**Issue List for Public Meeting Discussion
Mechanical Engineering Branch (contact: Yiu Law)**

DCD Tier 2, Section 3.9.5

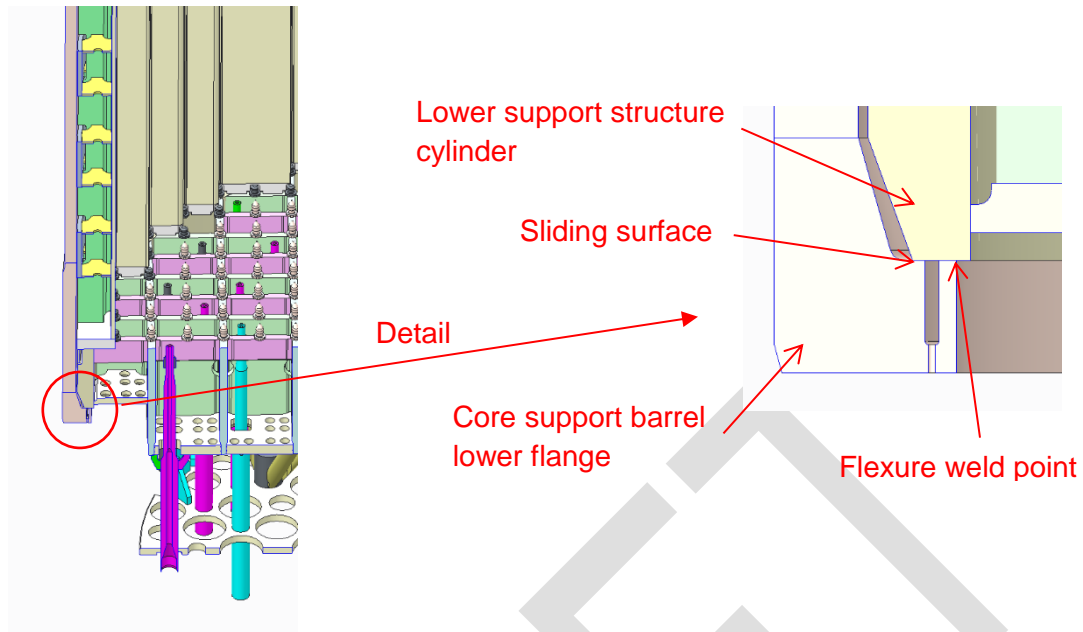
Based on the information provided in the DCD, it is unclear why the hold down ring is classified as an internal structure instead of a core support structure, since it provides direct support of the UGS assembly, which is a core support structure according to DCD Tier 2, Section 3.9.5.1. Therefore, the applicant is requested to provide justification of its current classification or revise the DCD to change the classification.

In addition, the applicant is requested to explain the potential loss of preload of the hold down ring due to stress relaxation during all service and accident conditions and its potential effect on the functional and structural integrity of the core support barrel assembly and the upper guide structure assembly.

The hold down ring provides axial force on the flanges of the UGS assembly and the core support barrel assembly in order to prevent movement of the structures under hydraulic forces. The hold down ring is designed to accommodate the differential thermal expansion between the reactor vessel and the reactor internals in the vessel ledge region. The UGS assembly and core support barrel assembly including hold down ring are supported on the reactor vessel ledge. Therefore, the hold down ring is classified as an internal structure since it is not a major component which provides direct support or restraint of the core within the reactor vessel.

Loss of preload may occur due to loss of deflection of the hold down ring as a result of wear on contact surface and stress relaxation during operation. This loss of preload will decrease an axial load on the core support barrel and UGS flange surface and then induce relative motion between the core support barrel and UGS flanges under service and accident loadings. Considering loss of preload, the hold down ring is designed to have enough preload to prevent relative motion of reactor internal components. The function of hold down ring is inspected via CVAP(Comprehensive Vibration Assessment

Program) and the visual inspection results have showed no relative motion of reactor internal components.

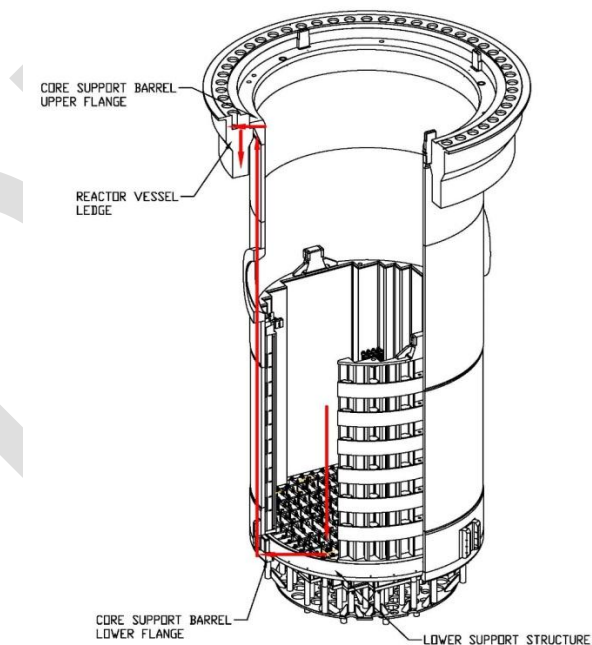
Based on the information provided in DCD Tier 2, Section 3.9.5.1.1 and Figure 3.9-9, it is not clear to the staff the configuration and geometry of either the lower flange of the core support barrel or the core support barrel welded flexural connection to the lower support structure. In addition, DCD Tier 2, Section 3.9.5.1.1 states that the core support barrel assembly is supported at its upper flange on the reactor vessel ledge. However, since the core support barrel lower flange is attached to the lower support structure by means of a welded flexural connection, it is unclear to the staff exactly which component(s) support the weight of the core and how much of the core support barrel and the core is supported at the reactor vessel ledge. DCD Tier 2, Section 3.9.5.1.1 also indicates that the lower support structure assembly is the primary component that supports the weight of the core, and Figure 3.9-8 shows that the lower support structure assembly rests on the clevis at the bottom of the reactor vessel. Therefore, the applicant is requested to provide the above clarification in the form of a more detailed description and drawings.

The configuration and geometry of the core support barrel welded flexural connection to the lower support structure are shown in the following figure. The lower flange of the core support barrel is attached to the lower end of the lower support structure cylinder by a welded flexural connection. The inside part in lower end of the lower support structure cylinder is welded circumferentially to flexure part in the lower flange top of core support barrel. The outside part in lower end of the lower support structure cylinder just slides on inside surface in the lower flange top of core support barrel to accommodate the differential thermal expansion between the lower support structure and the core support barrel.

The lower support structure assembly doesn't rest on the clevis at the bottom of the reactor vessel but on the lower flange of the core support barrel as above figure. The lower support structure directly supports the weight of the core and then transmits the load to the core support barrel lower flange. Finally all the loads of the core support barrel assembly and the core are supported at the reactor vessel ledge. Load path is described in the following figure.

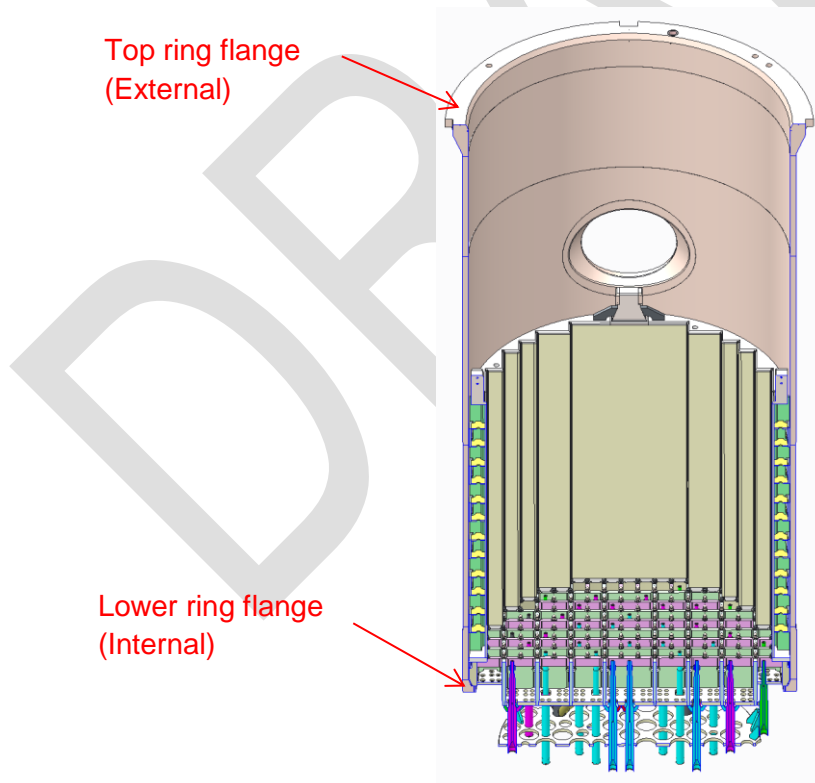
DCD Tier 2, Section 3.9.5.1.1.1 describes the core support barrel as a right circular cylinder including a heavy external ring flange at the top end and an internal ring flange at the lower end. It is unclear to the staff which component is the top ring flange and which component is the lower ring flange in DCD Tier 2, Figure 3.9-9. The applicant is requested to provide a more detailed drawing of the core support barrel that identifies these two ring flanges. In addition, the applicant is requested to describe the function of these two ring flanges and if they support any load during normal and accident conditions.

The configuration related to top and lower ring flange of the core support barrel is shown in the following figure.

The core support barrel assembly is supported at its upper end by the top ring flange of the core support barrel, which rests on a ledge in the reactor vessel. The lower ring flange of the core support barrel supports, secures, and positions the lower support structure including core.

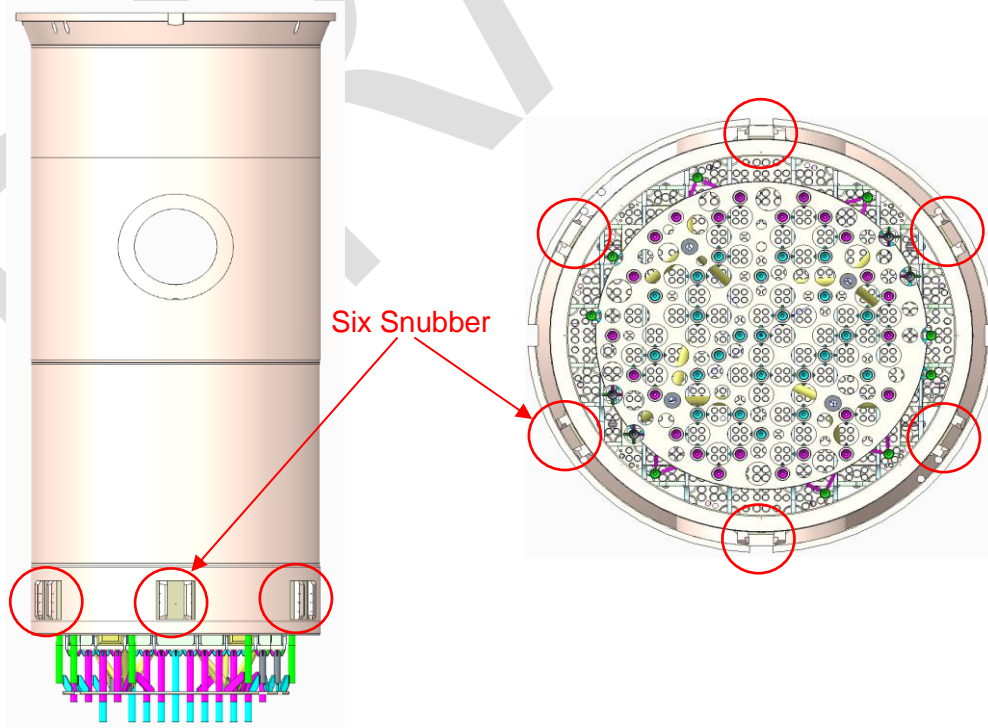
- a. The applicant is requested to explain the flow induced vibration effect on the snubbers under both normal and accident conditions.
- b. The applicant is requested to clarify if the snubber assembly, either the tongue and groove assembly on the core support barrel, or the mating lug on the reactor vessel, support any weight of the core support barrel and the core.

- c. It appears to the staff that there are four snubbers on the core support barrel as shown in DCD Tier 2, Figure 3.9-9, however, DCD Tier 2, Section 3.9.5.1.1.1 states that there are six snubbers. The applicant is requested to clarify this discrepancy.

- d. Figure 3.9-10 shows that four pins and four socket head cap screws are used for assembling the shims to the core stabilizing lug on the reactor vessel. However, no description is provided on how the tongue and groove assembly is attached to the core barrel assembly and how the core stabilizing lug is attached to the reactor vessel. Moreover, no description is provided for the pins and socket head cap screws, how these structural fasteners are classified, and the design code used for the design of these structural fasteners. Therefore, the applicant is requested to provide the information stated above.

- b. The snubber assembly does not support any weight of the core support barrel and the core. Only radial and axial expansions of the core support barrel are accommodated, but excessive lateral and torsional movement of the core support barrel is restricted by six snubbers.
- c. It appears that there are four snubbers on the core support barrel as shown in DCD Tier 2, Figure 3.9-9. But actually core support barrel has six snubbers as shown in the following figure. Left figure is front view of the core support barrel assembly and right figure is bottom view of the core support barrel assembly. Left figure presents only three snubbers. Another three snubbers are located at opposite side.

- d. Core stabilizing lug is attached to the reactor vessel with a full penetration weld. Two core stabilizing shims are assembled with one core stabilizing lug, and four cap screws are used to fasten the shims to the lug. After installing the screws, each cap screw head is line drilled, and one pin and one plug are inserted. The hole where the pin and plug pass through is welded to fix the screw. All parts of the core stabilizing lug are classified and designed as ASME Code Class 1 component (NB), therefore, the structural fasteners are designed by Section III, Subsection NB of the ASME Code.

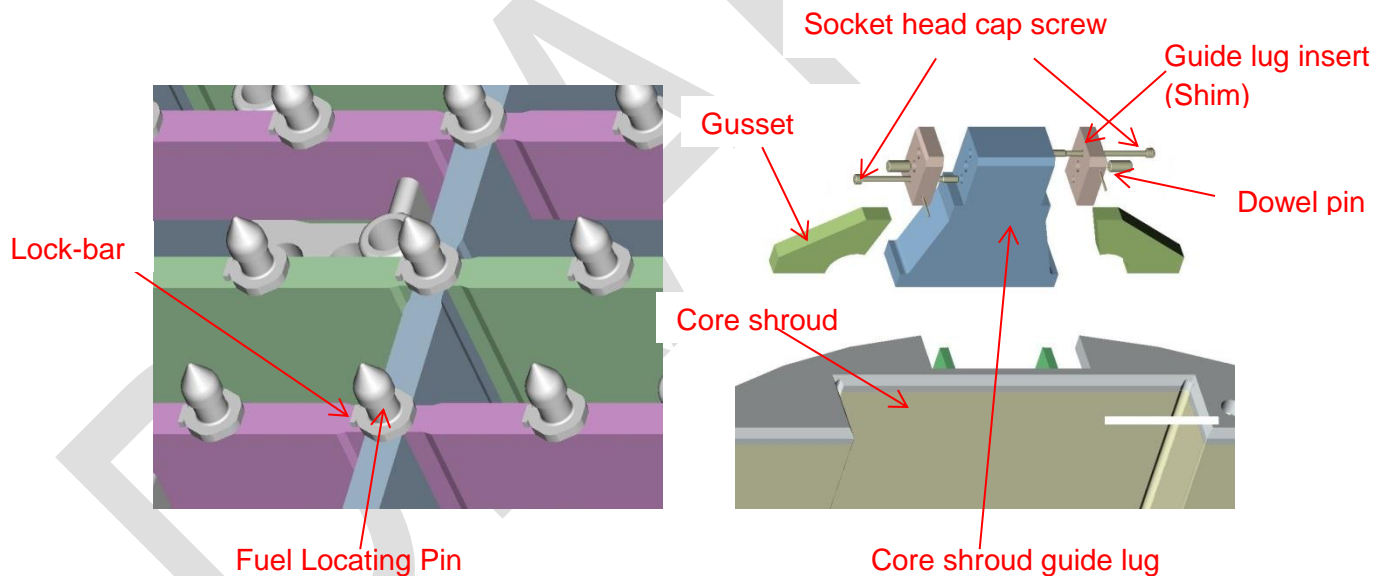
- e. The applicant is requested to clarify if threaded structural fasteners are used in other reactor internals components than those listed in item (d) above.

- e. The fuel locating pins and the socket head cap screws are used as threaded structural fasteners in reactor internal components as shown in the following figure. The fuel locating pins are attached to the top of lower support structure beams to provide orientation for the lower ends of the fuel assemblies. The fuel locating pins are secured as tack weld by lock-bar. The socket head cap screws are used to attach guide lug inserts (shims) to the core shroud guide lug. Four guide lugs, spaced 90 degrees apart, protrude vertically from the top of the core shroud and engage in corresponding slots in the UGS fuel alignment plate to provide proper alignment.

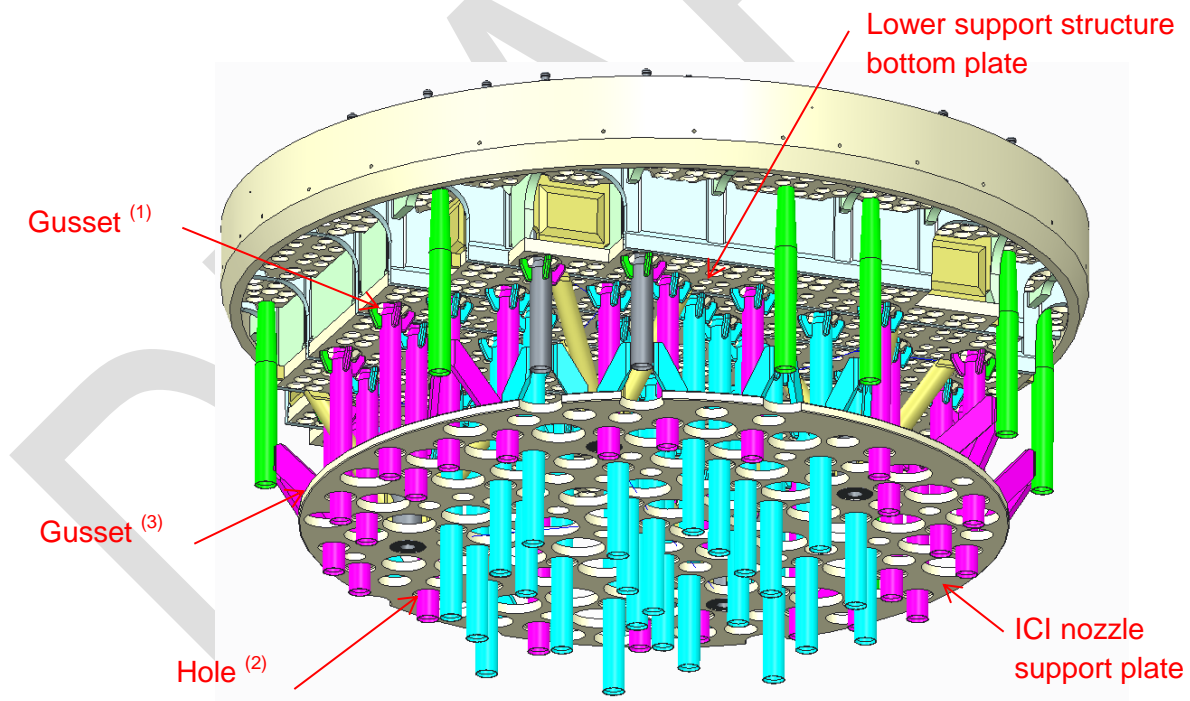
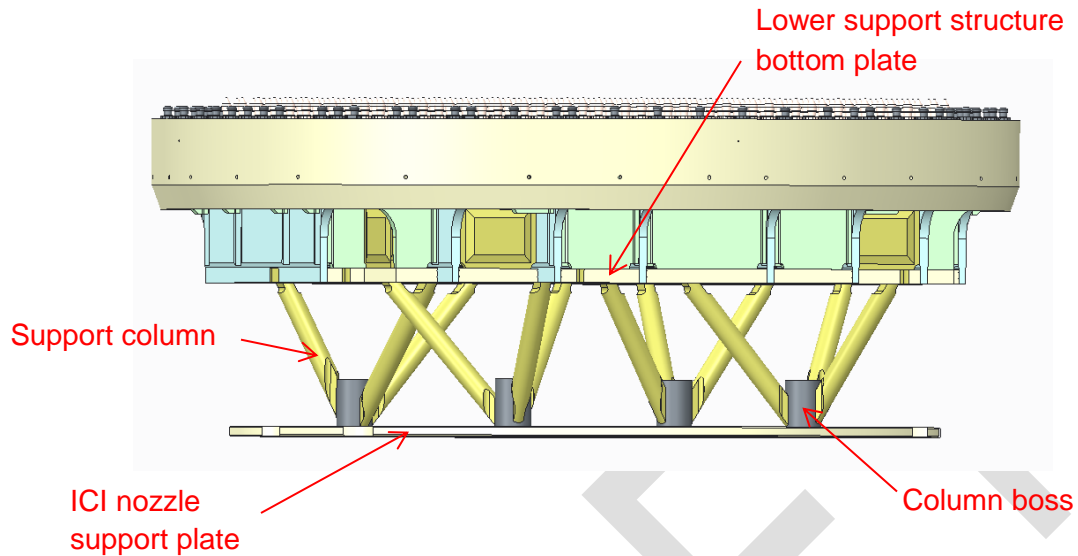
The applicant is requested to further describe and identify, either with additional drawings or in DCD Tier 2, Figure 3.9-11, the aforementioned array of plates that support the ICI nozzles, support columns, and ICI nozzle support plate. In addition, the applicant is requested to describe the following:

- a. The interface between the ICI nozzle to both bottom plate and ICI nozzle support plate
- b. The location, number, and function of the support columns, and their interfaces to the bottom plate and ICI nozzle support plate as shown in Figure 3.9-11
- c. The function of the gusset as shown in DCD Tier 2, Figure 3.9-11

The plates of lower support structure consist of bottom plate and raised bottom plate in DCD Tier 2, Figure 3.9-11. Basically the plates contain flow holes to provide a uniform flow distribution at the core inlet and the flow is up through lower support structure plate and then core. The plates are divided into the various flow hole patterns. The patterns are determined by factors such as the ICI locations, the intersection of the support beams with the bottom plate, and the boundary between raised (peripheral) and bottom (central) portions of the plate. The bottom plate is welded to the lower end of main support beam and the raised bottom plate is welded to the beams and the lower portions of lower support structure cylinder.

- a. The upper part of the ICI nozzle is welded to lower support structure bottom plate by gussets⁽¹⁾. The lower part (central) of the ICI nozzle is welded to the hole of ICI nozzle support plate⁽²⁾ and the lower part (peripheral) of the ICI nozzle is welded to ICI nozzle support plate by gussets⁽³⁾ as shown in following figure.

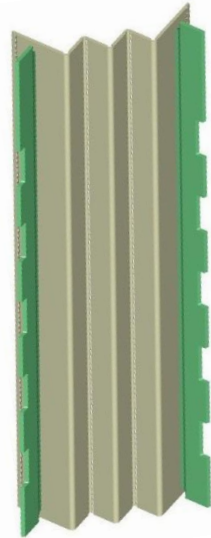
It is unclear to the staff based on this figure how the circumferential rings are attached to the vertical plates by means of full length welded ribs and horizontal braces. Therefore, the applicant is requested to describe how the circumferential rings are attached to the vertical plates. In addition, DCD Tier 2, Section 3.9.5.1.1.3 does not describe how the core shroud vertical plates are attached to each other. Therefore, the applicant is requested to provide this description. If structural fasteners are used, the applicant is requested to provide description on how these fasteners are designed and qualified under the intended operating life of the plant.

The upper and lower portions of the circumferential rings are attached to the cutout of the rib by weld as shown in following figures. The ribs are attached to the vertical plates by means of full length weld axially.

The core shroud vertical plates consist of four W-type plates and four C-type plates as shown in following figures. W-type plate and C-type plate are attached to each other by means of full length weld axially. Therefore the structural fasteners are not used to attach core shroud vertical plates.
